AGENDA
PLANNING COMMISSION PUBLIC HEARING/REGULAR MEETING
CITY OF FARMINGTON HILLS
AUGUST 20, 2026 at 7:30 P.M.
FARMINGTON HILLS CITY HALL – CITY COUNCIL CHAMBER
31555 W. ELEVEN MILE ROAD, FARMINGTON HILLS, MICHIGAN 48336
Cable TV: Spectrum – Channel 203; AT&T – Channel 99
YouTube Channel: <https://www.youtube.com/user/FHChannel8>
www.fhgov.com (248) 871-2540

A. SPECIAL APPROVAL SITE PLAN 56-7-2026

LOCATION:	29375 W. 10 Mile Road
PARCEL I.D.:	22-23-25-101-018
PROPOSAL:	Construct a new specialty veterinary clinic within the B-3, General Business District
ACTION REQUESTED:	Planning Commission Public Hearing (Special Approval Use)
APPLICANT:	Katharine Podsiad
OWNER:	Bhachandra Sata

Special Approval Use & Site Plan Review for The City of Farmington Hills

NORTH SIDE ELEVATION

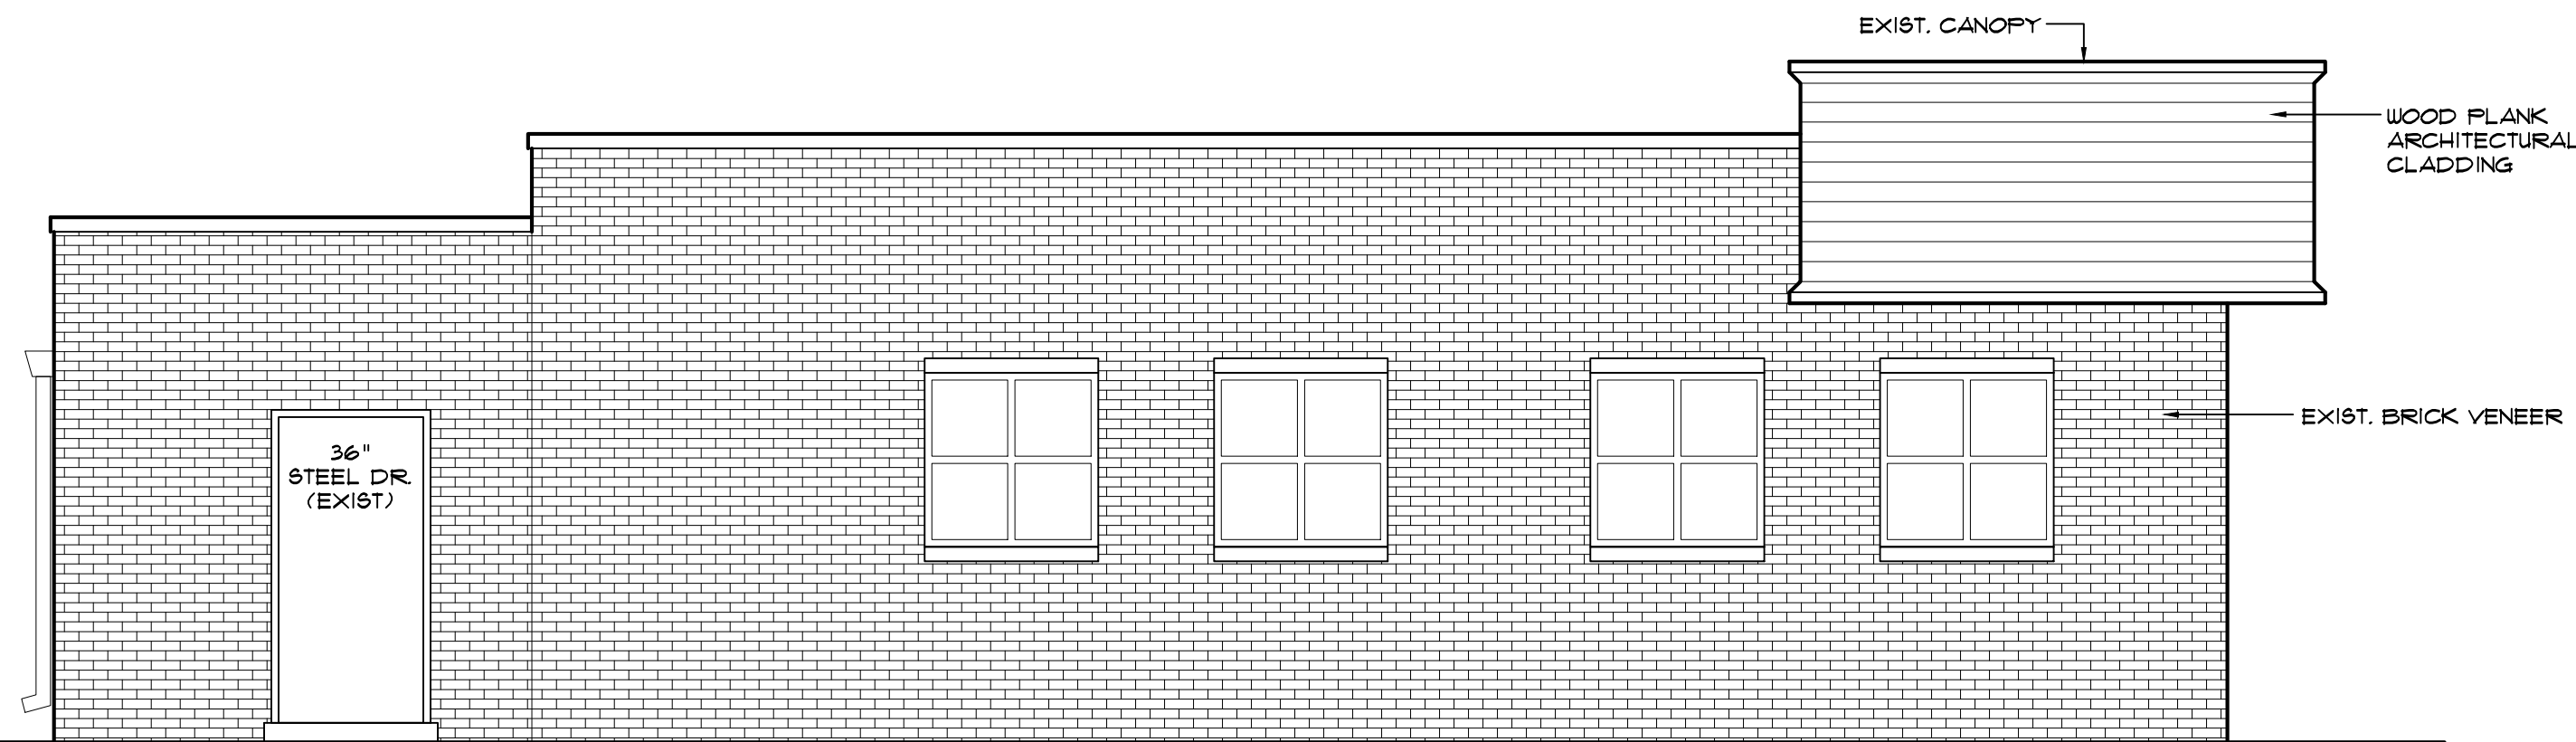
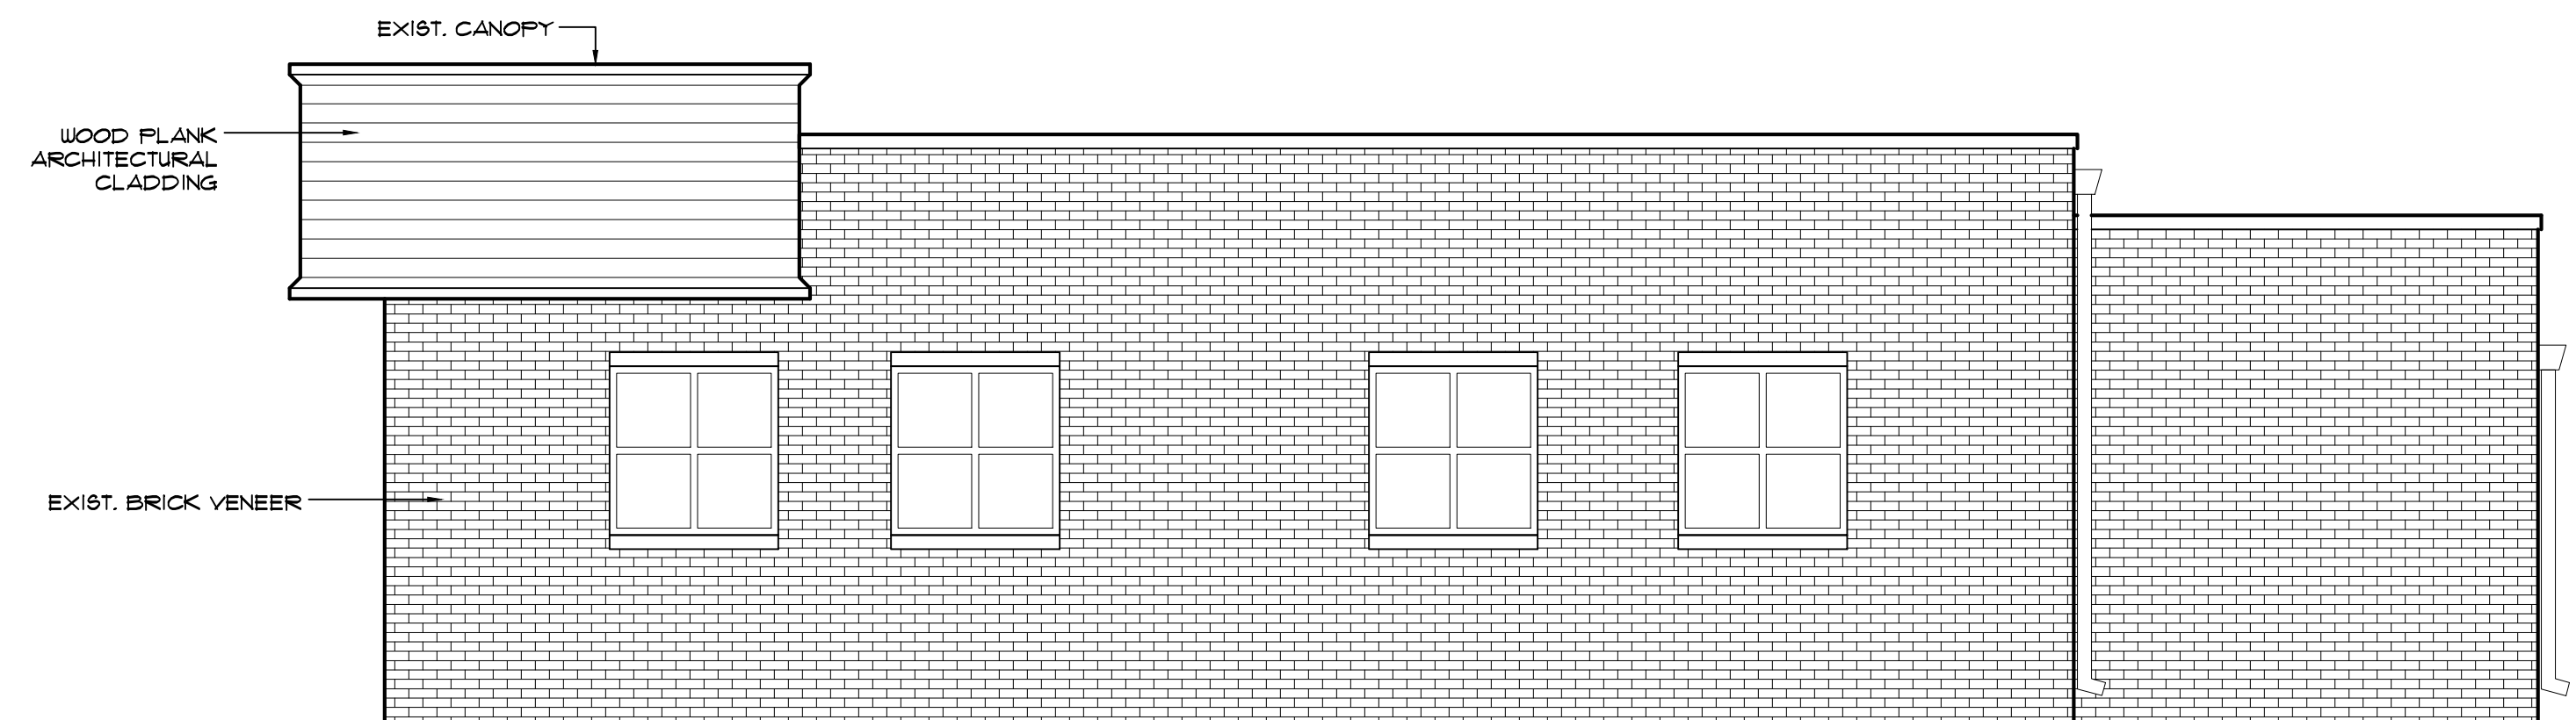
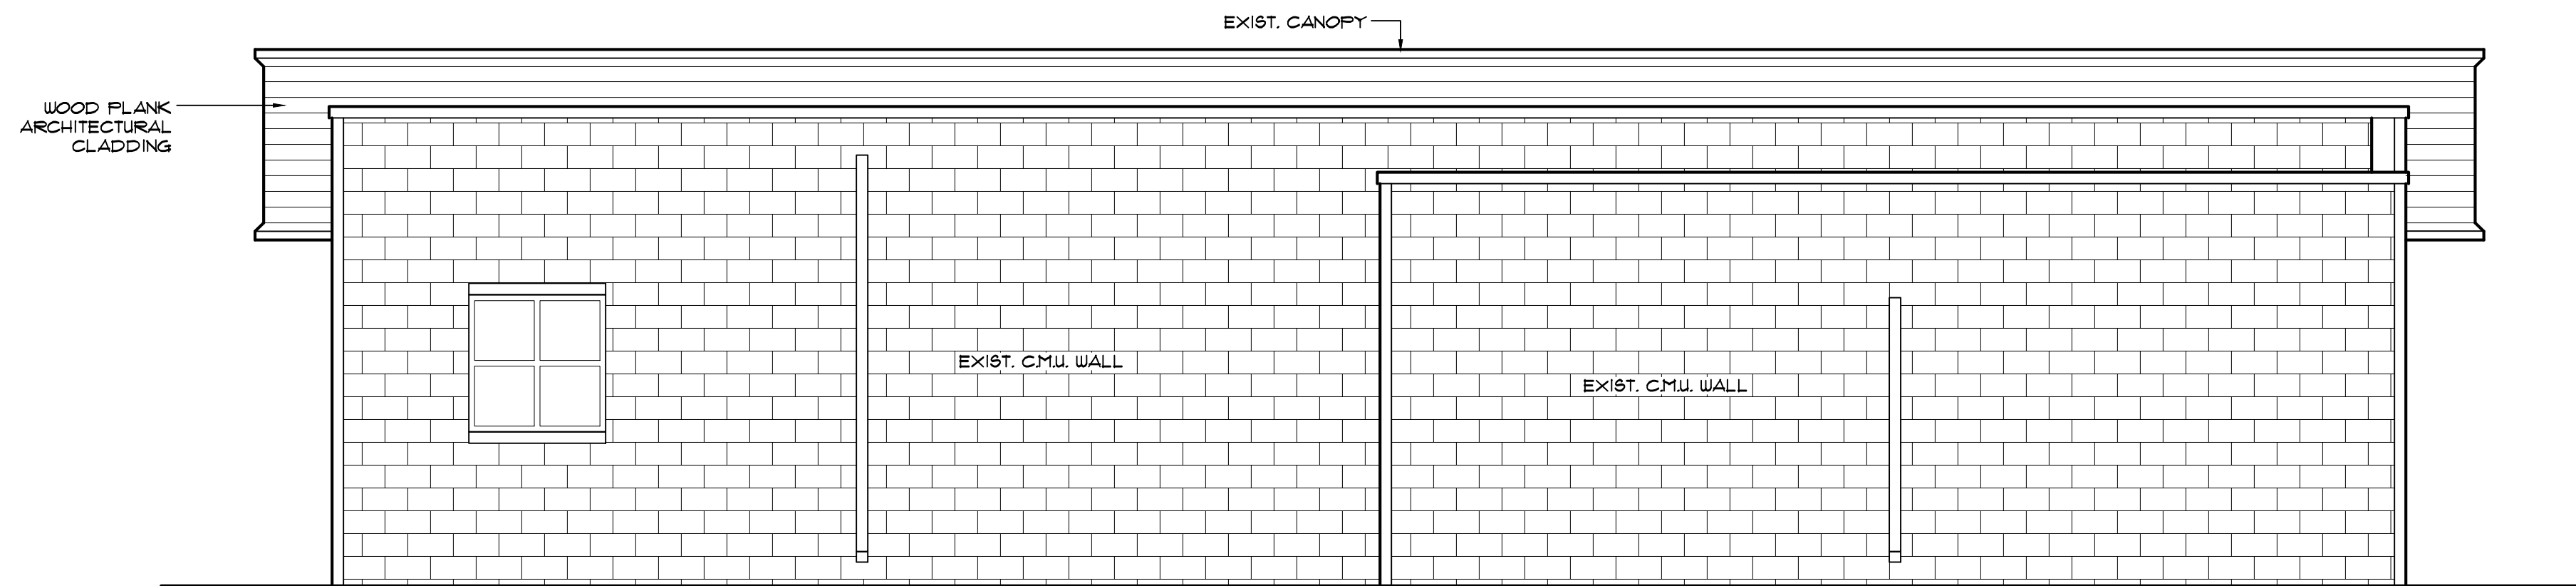
The applicant is proposing to renovate the building exterior to correspond with the interior clinic layout. The existing floor to ceiling windows will be removed and replaced with a wood plank architectural cladding. Four (4) windows that mirror the existing windows on the east and west ends of the façade will be added. The existing parapet will also be re-finished with wood plank architectural cladding.

Accent materials (34-5.20.4.B) The following may be permitted as accent materials on any building façade: • Glass block decorative • Metal and metal paneling • Decorative masonry veneer • Polymer plastic (e.g. Fypon, Azek) • Stucco • Plain or painted masonry block • Exterior Insulation and Finishing Systems (EIFS). EIFS may only be permitted when located at least 8 ft. above grade.	Pending. The applicant must confirm existing and proposed accent materials. Per Section 34-5.20.4.G. The Planning Commission may grant a waiver from the required building materials when the Commission finds <u>both</u> of the following apply: - The waiver will achieve a specific architectural objective or purpose. - The proposed building materials are compatible with surrounding development.
Material Palette and Colors (34-5.20.4.C) All building materials and colors shall be clearly labeled on the proposed building elevation plans.	Non-compliant. All building materials and colors shall be clearly labeled on the proposed building elevation plans. Colors and accent materials are not specified.

Design Standards	
Required	Provided
Architectural Scaling (34-5.20.5) All façades oriented toward a public right-of-way must provide windows and architectural scaling elements (such as vertical pilasters, columns, or other architectural elements) to break up the scale of the building. Building façades shall include no less than two of the following elements: i. Building color change. ii. Building material or texture change. iii. Projections or recesses extending along at least 20% of the façade. iv. Recessed entranceways or projecting vestibules. v. A horizontal expression line, such as a molding or reveal, shall define the transition between the ground floor and upper stories. If a one-story building is proposed, the horizontal expression line is not required.	Pending. Two (2) primary material types with different textures are proposed. Additional information will be necessary to determine if other design elements listed in Section 34-5.20.5 are present. However, the proposed design does not include any of the detail elements that create the visual variety intended by this section. We recommend that the applicants incorporate additional architectural materials or details to break up the visual scale of the building.

Design Standards	
Required	Provided
Fenestration (34-5.20.7.A) Facades facing a Major Thoroughfare: • Min. 60% ground floor fenestration. • Min. 35% upper floor fenestration. Facades facing a public ROW that is not a Major Thoroughfare: • Min. 50% ground floor fenestration. • Min. 20% upper floor fenestration.	Pending. Does not comply. Approximately ten (10) percent of the north elevation consists of windows. Per Section 34-5.20.7.F, the Planning Commission may grant a waiver from the building fenestration requirements if the Commission finds <u>one</u> of the following apply: - The waiver will achieve a specific architectural objective or purpose. - The proposed building materials are compatible with development surrounding - Compliance with the standard will result in a practical difficulty. Given the Zoning Ordinance's intent to ensure that veterinary clinic operations are limited to an enclosed building, a reduction may be warranted.

- 17) *Maximum illumination level in lumens must be provided.*
- 18) *The applicant must provide product specifications of the wood plank architectural cladding.*

- 19) *Existing and proposed accent materials must be specified on the plan.*

NORTH **PHOTOMETRIC PLAN**
SCALE: 1/8" = 1'-0"

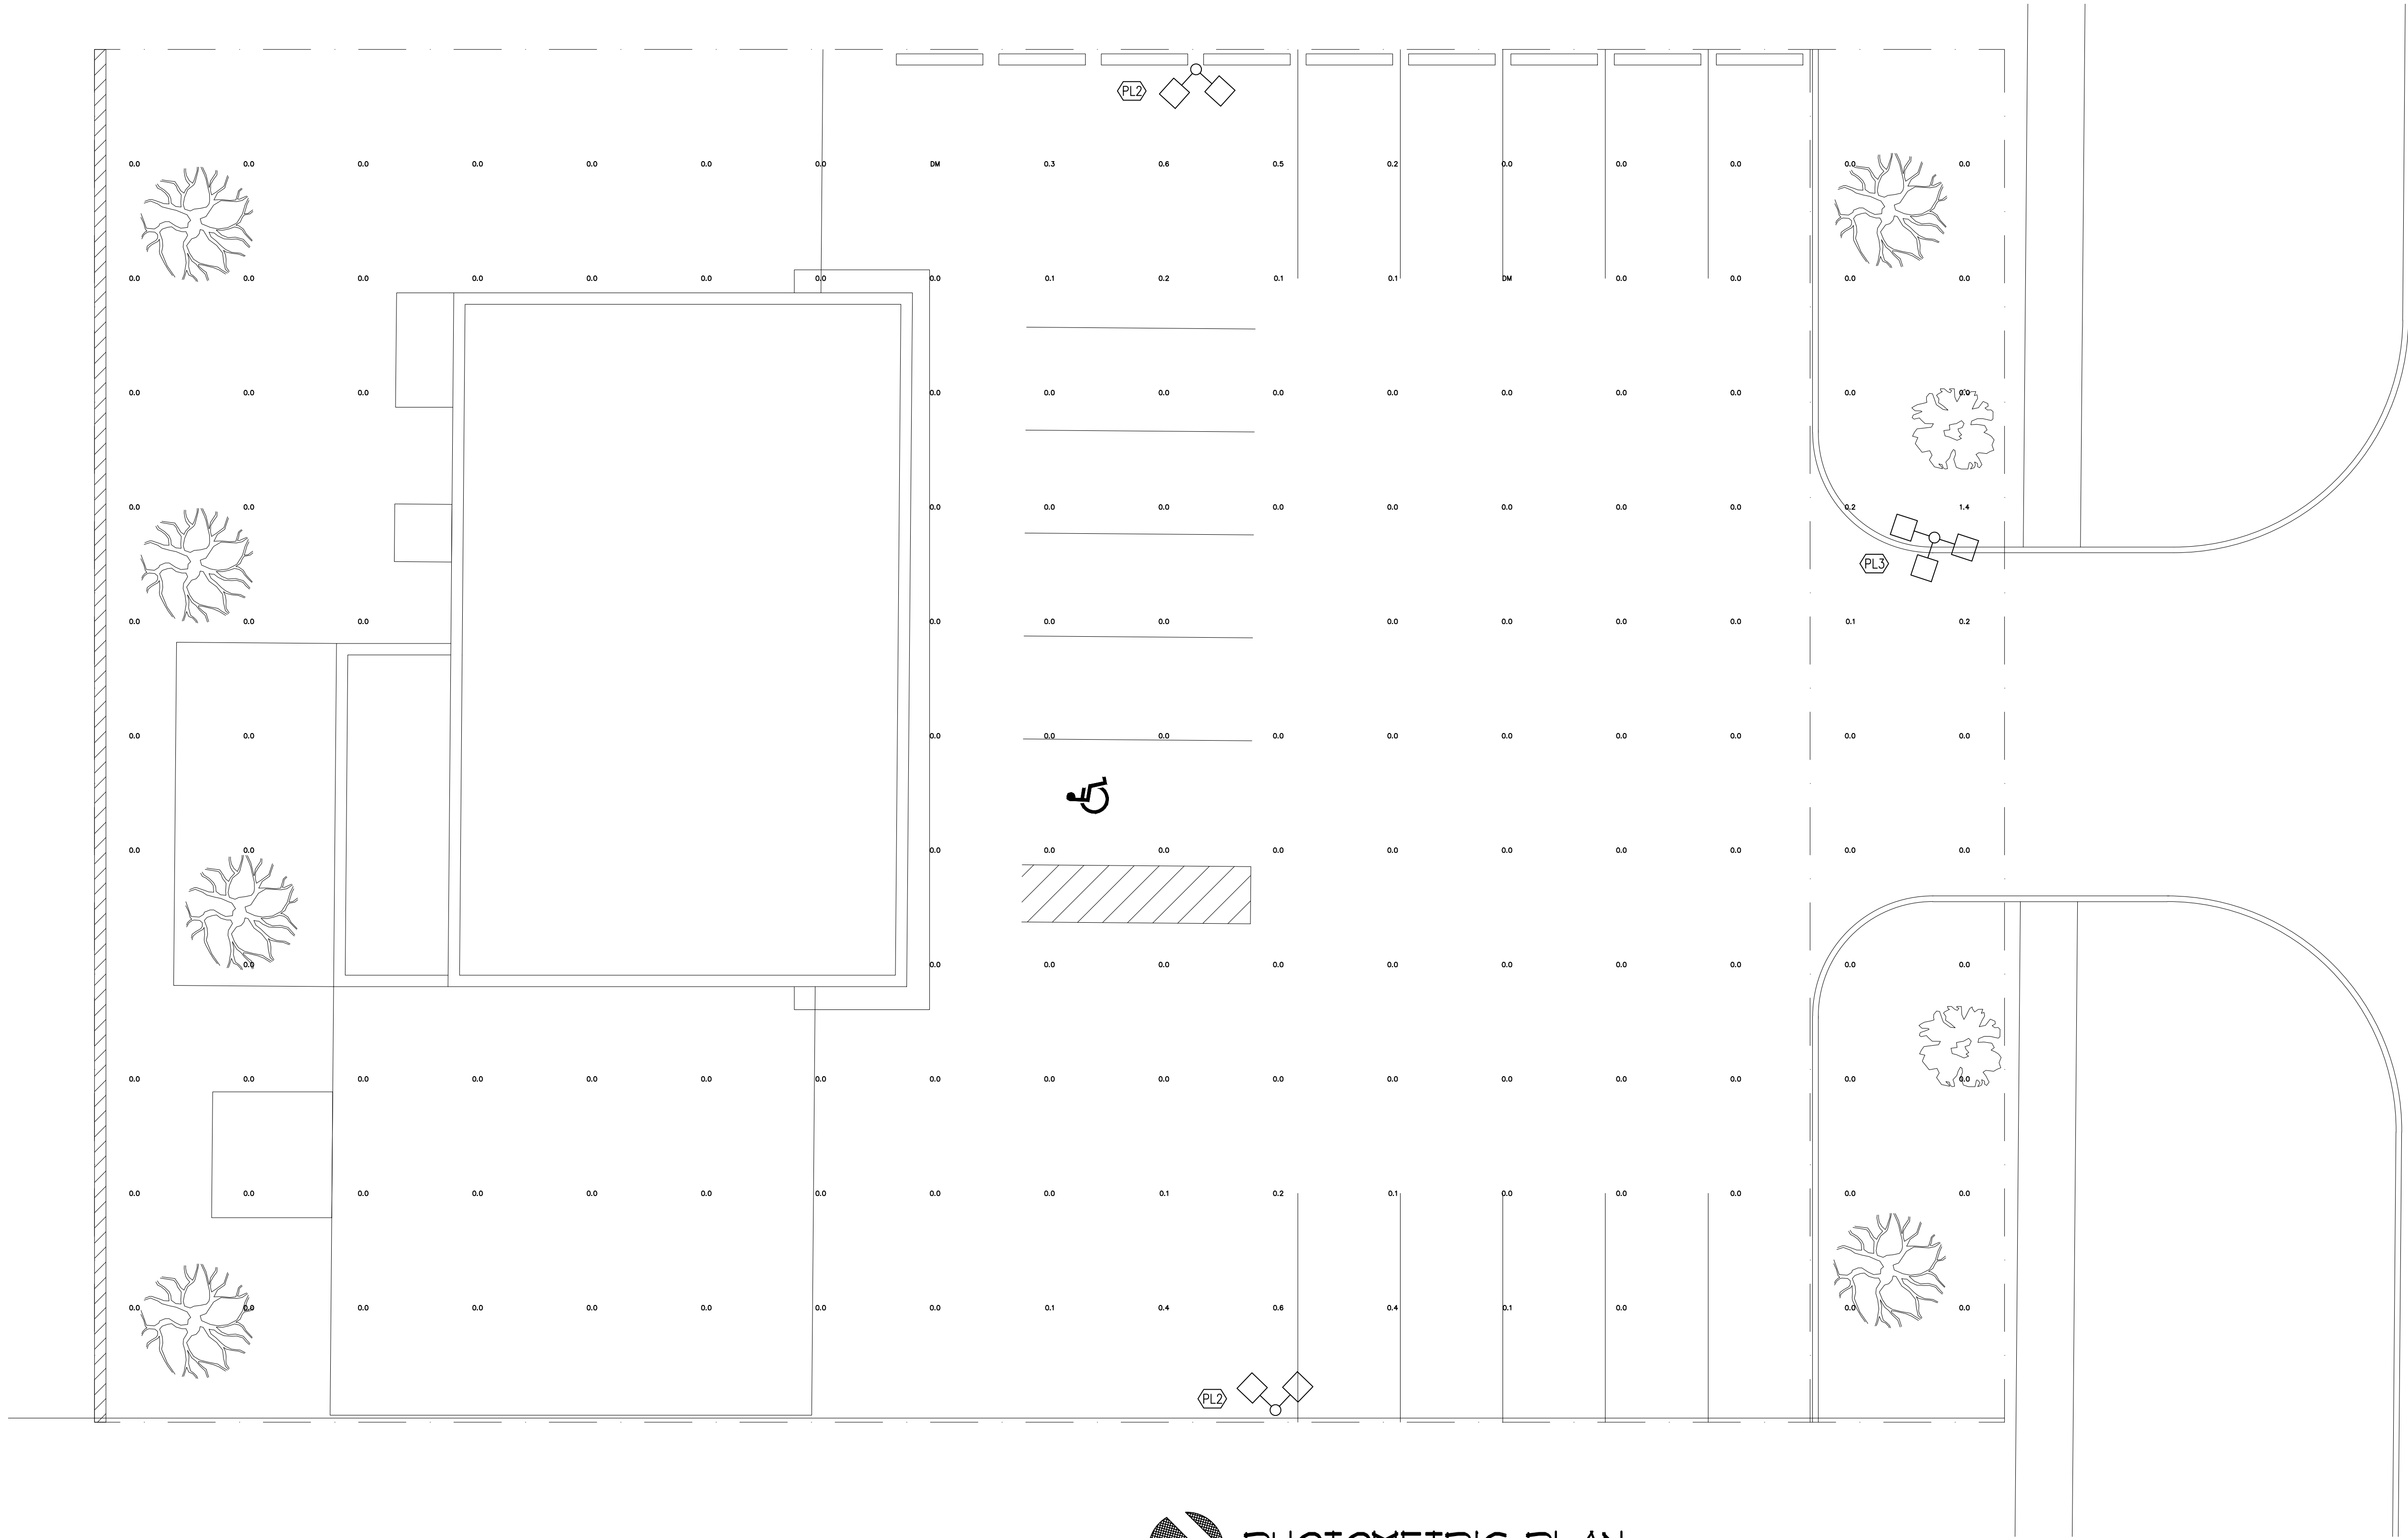
Exterior Lighting (34-5.16.3)		
Standard	Required	Provided
Max. Height (34-5.16.3.A)	30 ft.	Pending. The applicant must confirm if they intent to utilize the three (3) existing poles on site and confirm the height.
Building Mounted Lights (34-5.16.3.A.iii)	Relevant building elevation drawings showing all fixtures and the portions of the walls to be illuminated.	Pending. No building mounted fixtures are proposed. However, they may be necessary to illuminate the parking lot. See the comments below.
Fixture Shielding (34-5.16.3.B)	Parking lot lighting shall be designed to provide adequate vision and comfort in parking areas. Fully	Non-compliant. The photometric plan shows that the existing lighting will not illuminate the majority of the

- 14) *The photometric plan shows that the existing lighting will not illuminate the majority of the parking lot. Additional fixtures must be provided to adequately illuminate the parking lot.*

- 15) *The applicant must provide details of the proposed exterior light fixtures to confirm that they will be shielded.*
- 16) *The illumination ratio shown on the plan must be corrected*
